SUBJECT: Re-submittal of Safety Evaluation by the Office of Nuclear Reactor
Regulation of Electric Power Research Institute (EPRI) Topical Report
TR-1002865, "Topical Report on Reactivity Initiated Accidents: Bases
for RIA Fuel Rod Failures and Core Coolability Criteria"

SUBJECT: Safety Evaluation by the Office of Nuclear Reactor Regulation of
Electric Power Research Institute (EPRI) Topical Report TR-1002865,
“Topical Report on Reactivity Initiated Accidents: Bases for RIA Fuel
Rod Failures and Core Coolability Criteria”

Response to Requests for Additional Information (RAI's)
NRR Safety Evaluation Report – Project No. 689

Figure C-1.1 Comparison of fuel centerline temperature predictions by FALCON BETA RIA, using MATPRO-11/ESCORE, FRAPTRAN and NFIR thermal conductivity models with thermocouple measurements for the Halden irradiation test IFA-515.10 Rod A1.

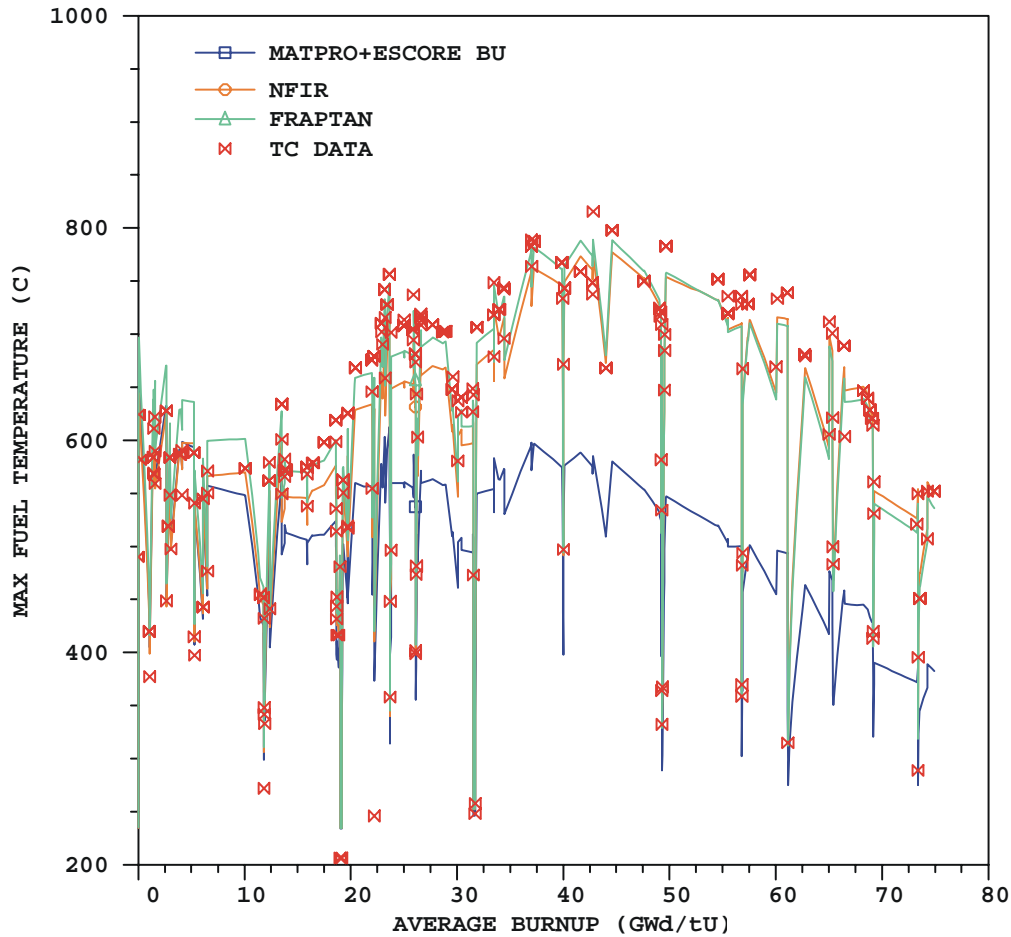
The basis for the statement on the underestimation of the fuel temperature at high burnup in FALCON was not provided; so several aspects and considerations for the coolability calculation are described below. The response comprises two parts: 1) validation of the best-estimate fuel temperature calculation in FALCON under RIA conditions against applicable data and 2) sensitivity of the fuel temperature calculation to the UO₂ thermal conductivity model.

Comparison of the FALCON BETA-RIA steady state temperature calculations with thermocouple measurements shows that the baseline UO_2 thermal conductivity correlation results in a underestimation of the fuel centerline temperatures by ~200°C at pellet average burnup levels exceeding 30 GWd/MTU. A comparison to thermocouple measurements for the Halden irradiation test IFA-515.10 Rod A1 is shown in Figure C-1.1. Also shown for comparison is the FALCON calculated fuel temperatures using the FRAPTRAN [C-1.4] and NFIR [C-1.5, 6] UO_2 thermal conductivity correlations. The results for these two correlations agree well with the thermocouple data and are almost indistinguishable from each other.

Figure C-1.2 shows a comparison of the calculated and measured cladding elongation during RIA-simulation tests on high burnup fuel rods in CABRI and NSRR. Good agreement is found between predicted and measured results for a variety of fuel rod designs and burnup levels. Because of the small residual pellet-cladding gap, these results reflect the expansion of the fuel column during the energy deposition. Since this expansion is proportional to the pellet

Figure C-3.1 Comparison of the Coolability Limit Proposed in the EPRI Topical Report and the Japanese Coolability Limit [C-3.2]. Selected high fuel enthalpy test rods shown for comparison.

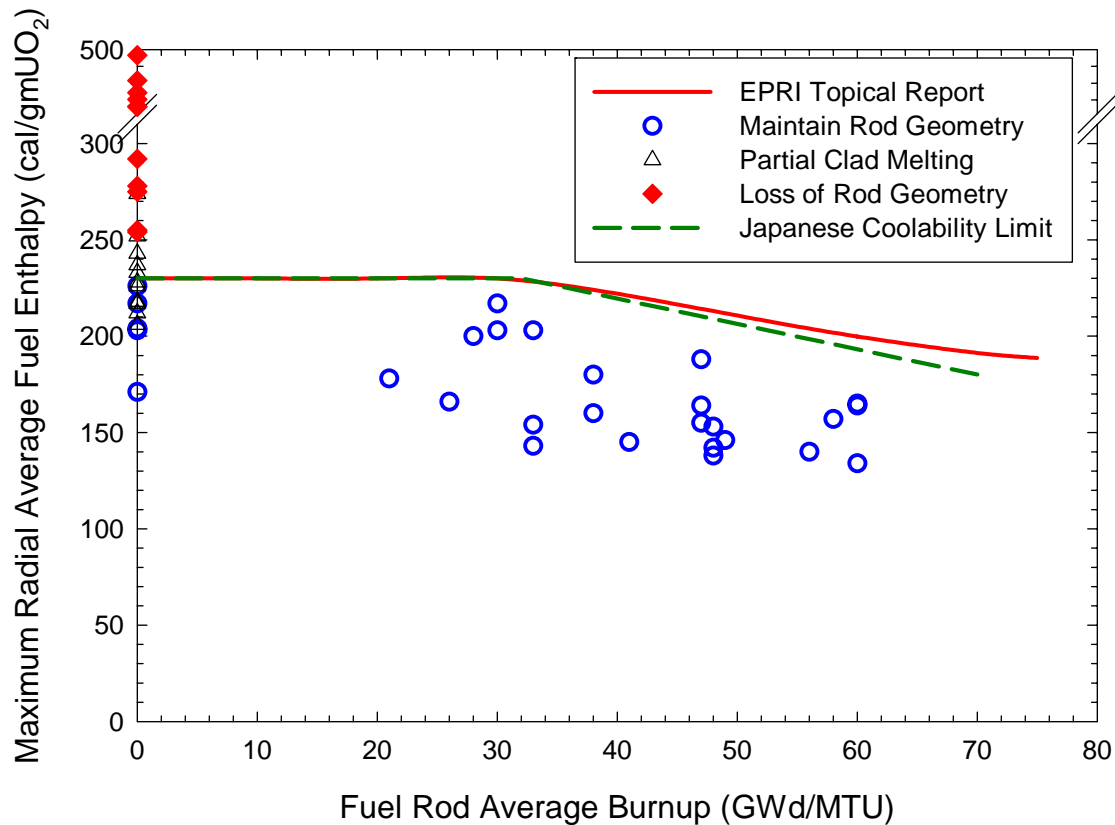
C-3. Although we believe there may be a justifiable coolability limit at an enthalpy above the Research Information Letter (RIL)-0401 cladding failure threshold, we cannot accept the proposed limit because of the lack of experimental data. Assertions are made about limited amounts of fuel dispersal, small magnitude of pressure pulses, and inefficient energy conversion of non-molten particles. However, these assertions are based mostly on tests in the Nuclear Safety Research Reactor (NSRR) with medium-to-high-burnup specimens under conditions that are far from typical for a nuclear power plant. No analysis is presented that would allow one to interpret these data or to compare predicted light-water reactor pressure pulses with vessel limits. We do not believe it is adequate to assume that molten fuel is needed to produce an energetic fuel-coolant interaction and then use a burnup-dependent melt enthalpy as the limit.

The following discussion addresses the two key observations/questions contained in the RAI:

Figure F-1.1 Best-fit CSED models for non-spalled (solid) and spalled (dashed) oxide layers developed from cladding mechanical property tests. The FALCON calculated SED values for the CABRI REP Na test conducted on UO_2 fuel rods shown for comparison.

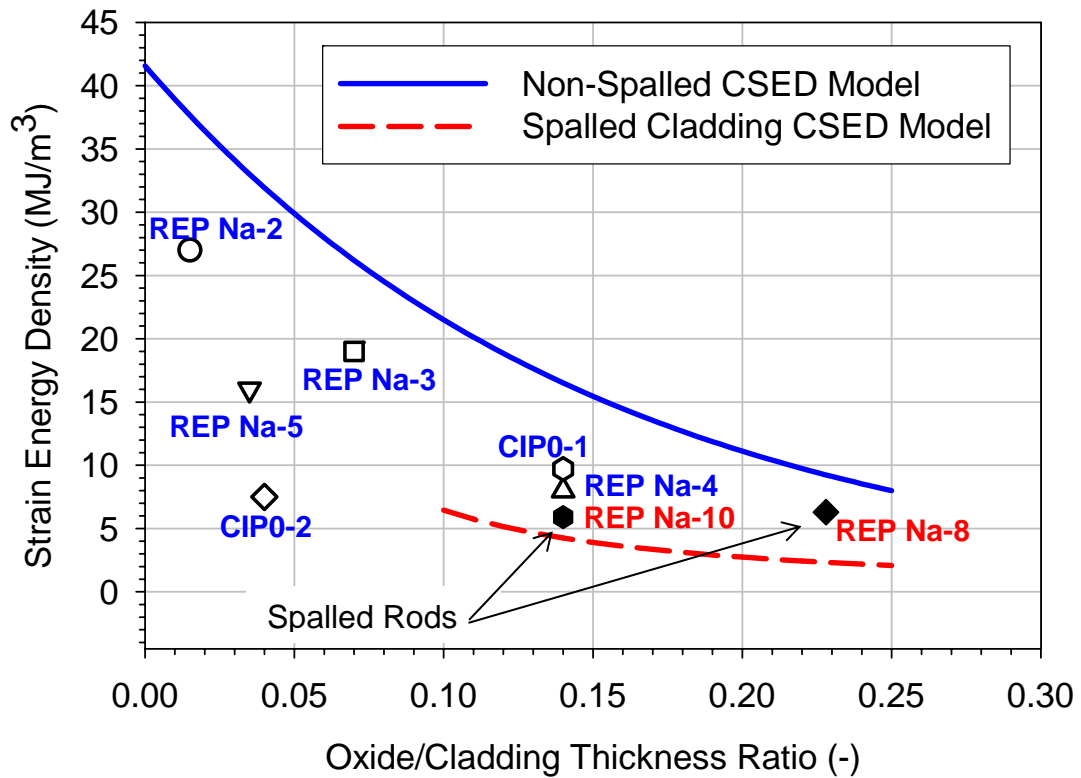
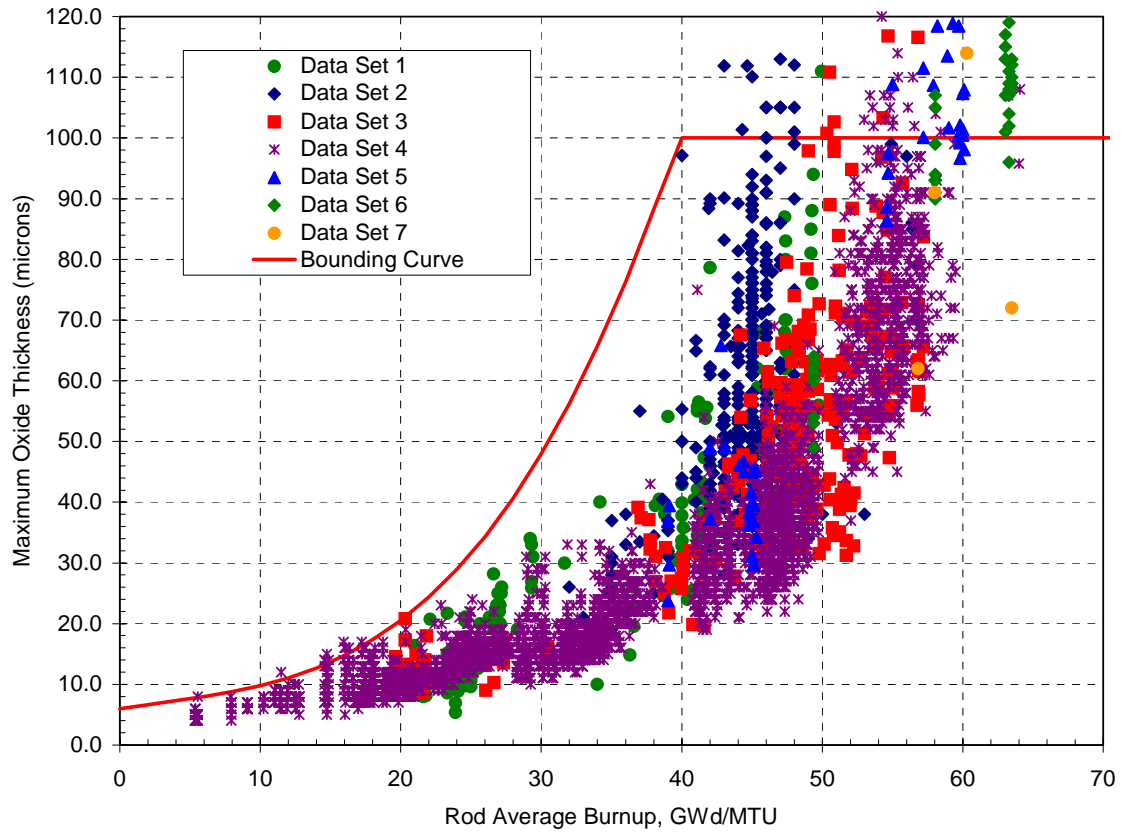
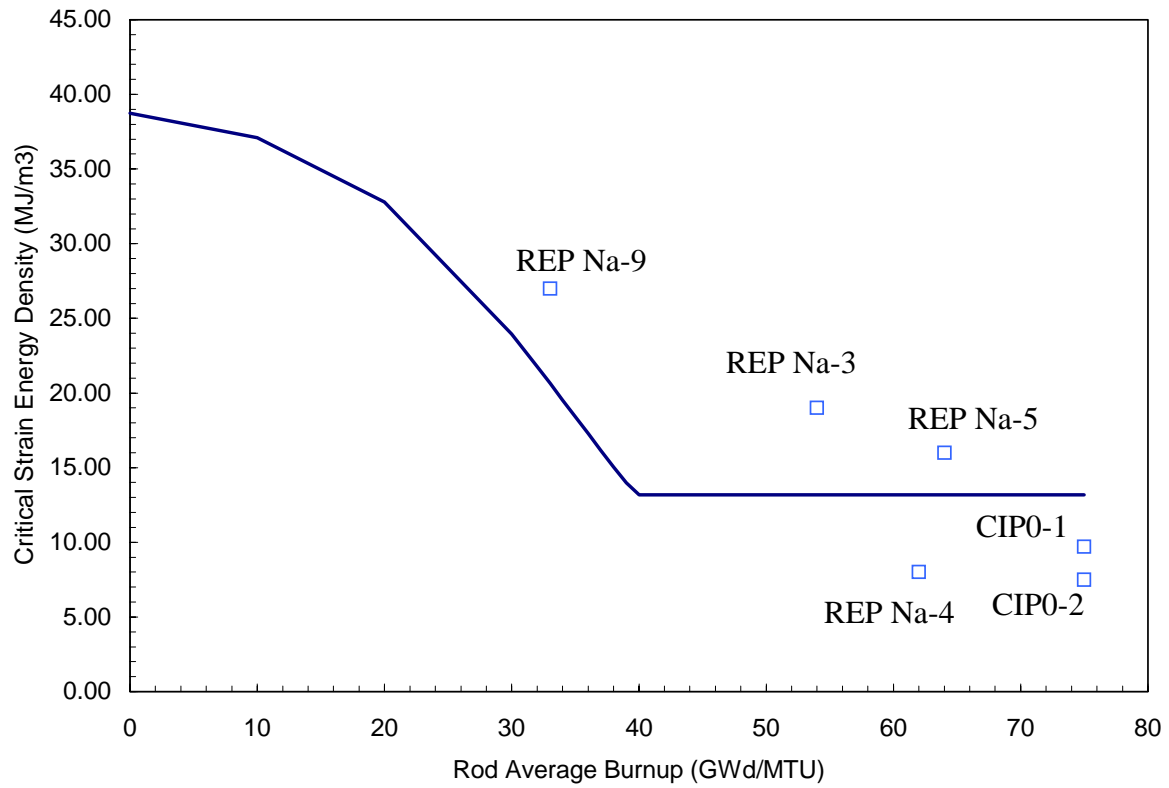
The response to RAI F-1 is divided into three parts. First, the reasons for using a best-fit curve to the CSED database to develop the cladding integrity model are described. Second, the use of the cladding integrity model combined with conservatism in developing the fuel rod failure threshold described in the RIA Topical Report is described. Third, the conservatism within the radionuclide release assumptions used to calculate the dose consequences are described.

Second, comparison of the maximum SED calculated by FALCON during the RIA simulation tests in CABRI UO₂ fuel with the best-fit CSED curve finds that all the non-failed tests reside below the best-fit CSED curve for non-spalled cladding material confirming the non-failed outcome for these tests. This result is shown in Figure F-1.1. Significantly lowering the non-spalled CSED curve to the lower bound of all the CSED data would result in prediction of failure for all the non-spalled UO₂ tests in CABRI, which would be inconsistent with the outcomes of these tests. Conversely, the failed UO₂ rods in the CABRI tests were all from test segments containing oxide spallation and the calculated SED for these tests reside above the best-fit CSED curve for spalled cladding material confirming the failed outcome for these tests.

This can be seen when the upper bound oxide thickness curve is used in the CSED correlation given by Equation 2-12 in the Topical Report. This approach produces a lower bound CSED versus burnup curve for non-spalled cladding, which is shown in Figure F-1.3 along with a comparison of the FALCON calculated SED for the CABRI REP Na UO_2 tests without oxide spallation. None of these test rods failed during the experiments in CABRI. The conservative nature of the CSED versus burnup curve is evident in Figure F-1.3 where three of the experiments reside well above the curve, yet none of these rods experienced cladding failure. Three non-failed tests lie below the bounding CSED curve shown in Figure F-1.3. Since the cladding SED is a function of the fuel enthalpy, the low levels of fuel enthalpy reached in each

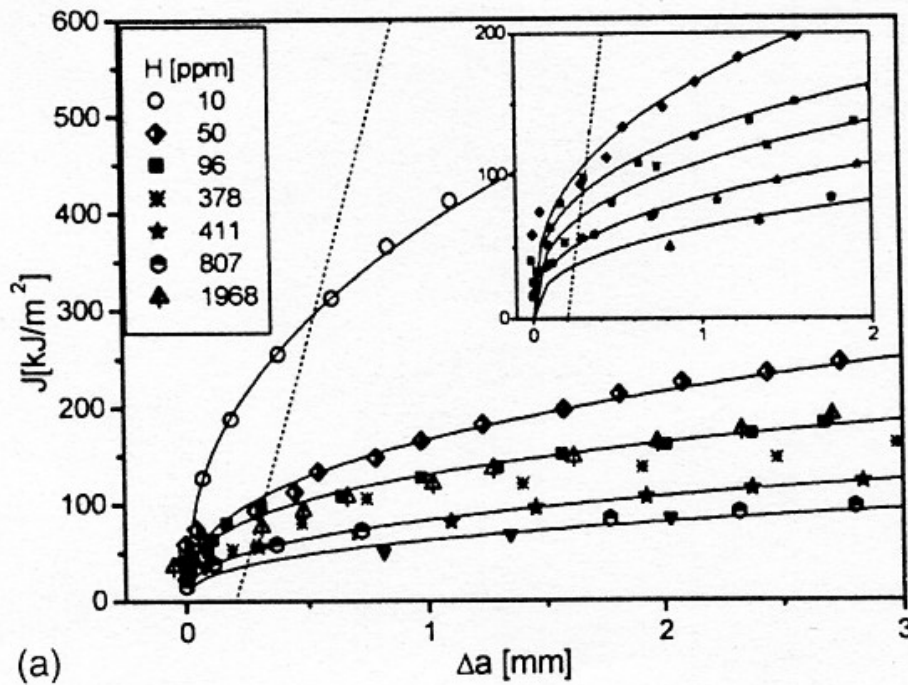
It was suggested in the review comment, based on the above ASTM 1820 analogy, that the SED/CSED methodology may not be applicable to high-burnup cladding. The comment goes on to say,

“This lack of applicability for the J-integral tests is further demonstrated by examining the available open literature J-integral data from irradiated Zircaloy with high hydrogen content. A plot of the J-integral data from Zircaloy versus hydrogen content does not show a discernable dependence, while a plot of the plane strain fracture toughness (K_{IC}) demonstrates a definitive dependence with a significant decrease in K_{IC} with increasing hydrogen content, which is expected due to hydrogen embrittlement”.

Before commenting on Bertolino et. al. data, we refer the reviewer to two articles: Grigoriev et. al. (*ASTM STP 1295, 1996, pp.435-447*, Figure 8), and Edsinger et. al. (*ASTM STP 1354, 2000, pp. 316-339*, Figure 9), which show a clear trend of hydrogen dependency in their fracture initiation data. Both Grigoiev and Edsinger used BWR cladding specimens, while Bertolino used ASTM 1820 Zr-4 specimens. One should not ignore the Grigoriev and Edsinger results simply because they used non-ASTM specimens. One may argue that Grigoriev’s and Edsinger’s results may be influenced by the effect of Zr-2 texture on hydride morphology, but their results nevertheless belong to the present discussion.

As already noted, the Bertolino et. al. data is stable-crack-extension data generated in accordance with the ASTM 1820 Standard, and had the authors included in their paper crack initiation data explicitly, a discernable dependence on hydrogen would have been observed. In fact, upon closer examination of the Bertolino data, one can discern in Figure 7a, at $\Delta a \approx 0$, sensitivity to hydrogen. This figure is reproduced here for easy reference. The lack of sensitivity to hydrogen in the stable crack growth stage could be due to any number of reasons, not the least of which is the effect of hydride morphology, which may change during the test as the result of unloading and reloading procedure dictated by the testing method. In a sense, one might say that for this reason alone the test disqualifies itself for hydrided material. This is over and above the fact that Bertolino’s “fracture toughness” values do not apply to cladding geometry or behavior under the conditions we are discussing.
